Hesitation On Acceleration From a Slow Roll or Rolling Stop

Service Category Engine/Hybrid System

YEAR(S)	MODEL(S)	ADDITIONAL INFORMATION
2019	RAV4

Figure 1. Location of Authorized Modifications Label on 2019 RAV4

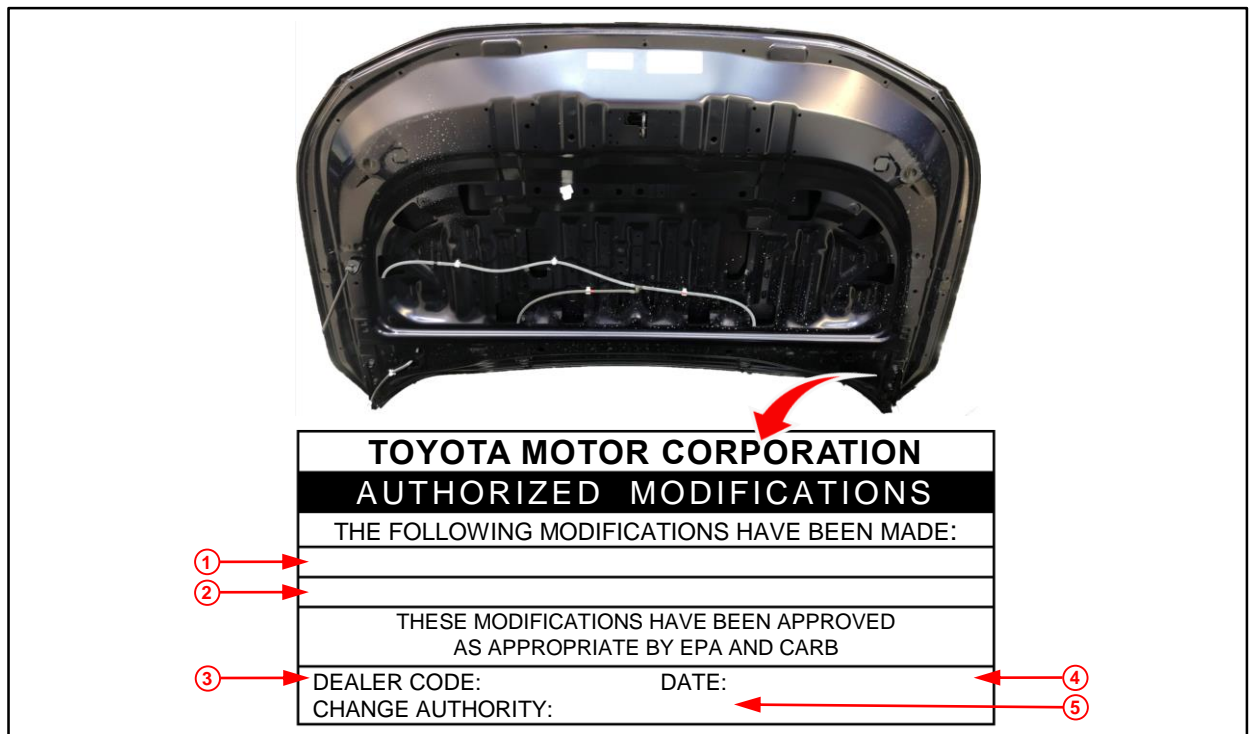
2. Use Techstream to confirm if the ECM (PCM) calibration has been updated and check for the Authorized Modifications Label affixed to the vehicle in the location shown below.

Is the calibration ID listed in Techstream and on the label the latest ECM (PCM) calibration?

B. Install the Authorized Modifications Label onto the vehicle at the location shown in Figure 1. The Authorized Modifications Label is available through the MDC, P/N 00451-00001-LBL.
